Title: Friends of Dublin Analysis Report – Riviera Development

Case Number: 14-0068Z/PDP

Report Author: Friends of Dublin

proposal, the Friends of Dublin has compiled an alternative analysis and report to those provided by both City staff and the developer.

In the diagram below (2024 AM Peak Hour – Full Build) from page 15 of the traffic study, the traffic counts anticipated from the new development making movements that would indicate potential trips to Dublin Jerome High School will total 38 trips.

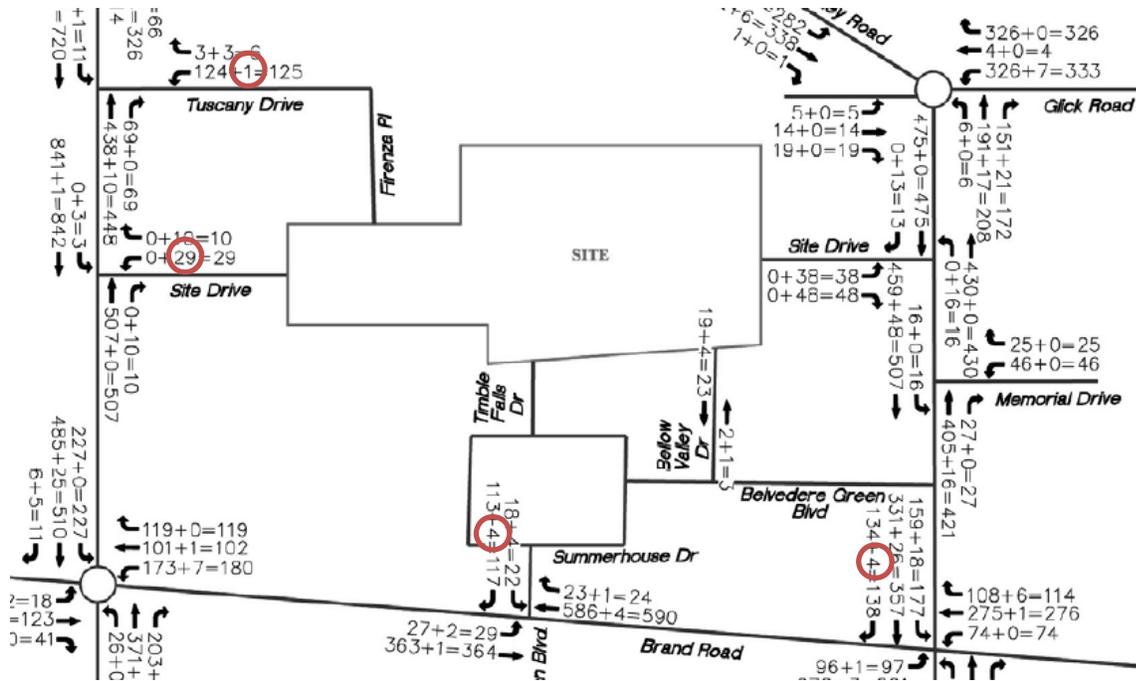
As noted in the diagram above, ambient traffic from the existing Belvedere subdivision of 154 homes generates 113 right turns from Abbie Glenn Blvd onto Brand Rd heading towards Dublin Jerome High School at the southern exit of the subdivision. It is not reasonable to assume that a subdivision of 154 homes generates 113 trips while a subdivision of 247 homes will only generate 38 trips.

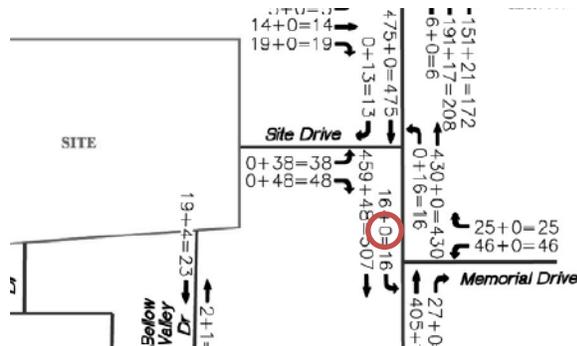
The current application fails to meet the Connectivity Principle of improving the function of the street network and to also better serve neighborhoods. While this application does provide for neighborhood connectivity, it does so at great cost. Again, one only needs to look at the traffic study to see examples of unusual anomalies in the conclusions drawn by the study. As an example, in all scenarios listed, the number of cars that would make a movement from the Avery Rd. exit of the site onto Memorial Dr. is exactly zero. It simply is not reasonable to assume that there will be no traffic impact to Memorial Drive from a 240 home subdivision located immediately north of Memorial Drive.

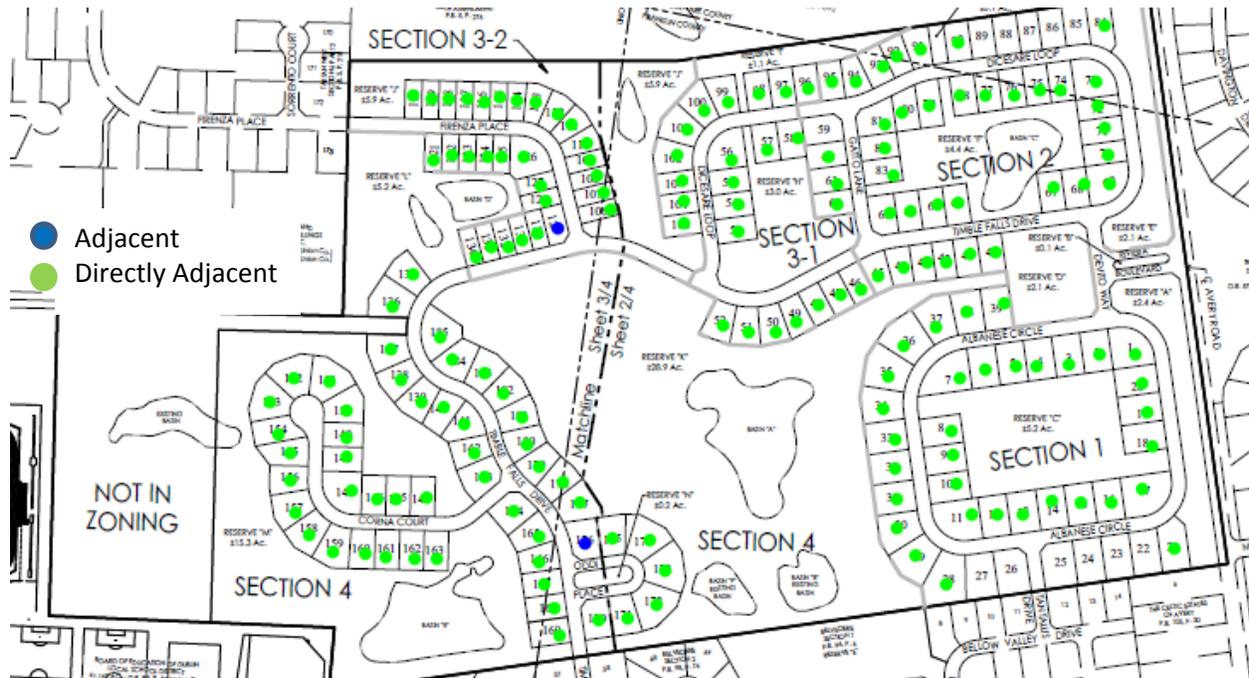
In the current configuration the application meets the 75% threshold with 174 lots or 94% meeting this requirement. 172 lots are directly adjacent while 2 are across a public street. Dublin Code does not directly define "directly adjacent" but infers the meaning that a parcel must abut open space to be considered directly adjacent.

To meet the 75% criteria, the application would need to have at least 139 lots adjacent to Open Space. The application meets the most stringent definition of “directly adjacent”.
